**SOLICITATION AMENDMENT
MODIFICATION DE L'INVITATION**

Title - Sujet GOCB Flooring & Fire Separations	
Solicitation No. - N° de l'invitation EW038-190845/A	Amendment No. - N° modif. 001
Client Reference No. - N° de référence du client PSPC	Date 2018-08-07
GETS Reference No. - N° de référence de SEAG PW-\$PWU-066-11410	
File No. - N° de dossier PWU-8-41059 (066)	CCC No./N° CCC - FMS No./N° VME
Solicitation Closes - L'invitation prend fin at - à 02:00 PM on - le 2018-08-14	Time Zone Fuseau horaire Mountain Daylight Saving Time MDT
F.O.B. - F.A.B. Plant-Usine: <input type="checkbox"/> Destination: <input type="checkbox"/> Other-Autre: <input type="checkbox"/>	
Address Enquiries to: - Adresser toutes questions à: Lee, Mony	Buyer Id - Id de l'acheteur pwu066
Telephone No. - N° de téléphone (780) 224-6675 ()	FAX No. - N° de FAX (780) 497-3510
Destination - of Goods, Services, and Construction: Destination - des biens, services et construction:

Addendum 001:Aug, 02nd, 2018

Fort Simpson GOCB Carpet Replacement & Fire Rating Upgrade

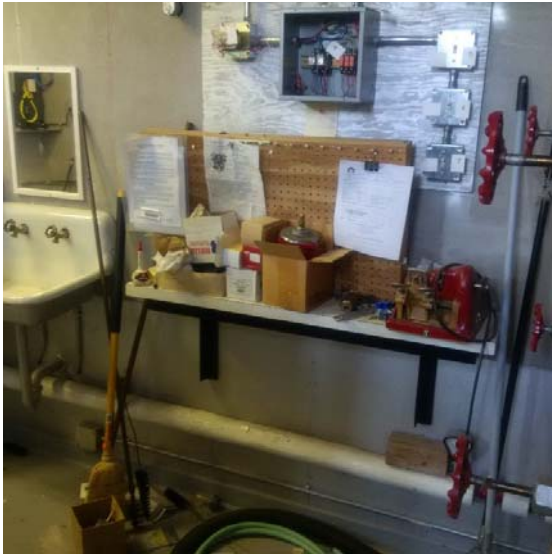
Contractor is to include the temporary removal of mechanical/electrical equipment, shelving, sink, and conduit etc. which has been mounted on the boiler room side of the new P1 wall, in order to install the new 2-ply rated gypsum wall board on the P1 walls.

The contractor is to keep all electrical service operational and boiler room functions operational, where this is not possible, the contractor is to contact the Department representative to schedule a time for this to take place after hours. Photos of the existing site conditions is in the appendix of this document.

Contractor to reinstall all equipment, shelving, sink, and conduit that had been temporarily removed onto new P1 wall.
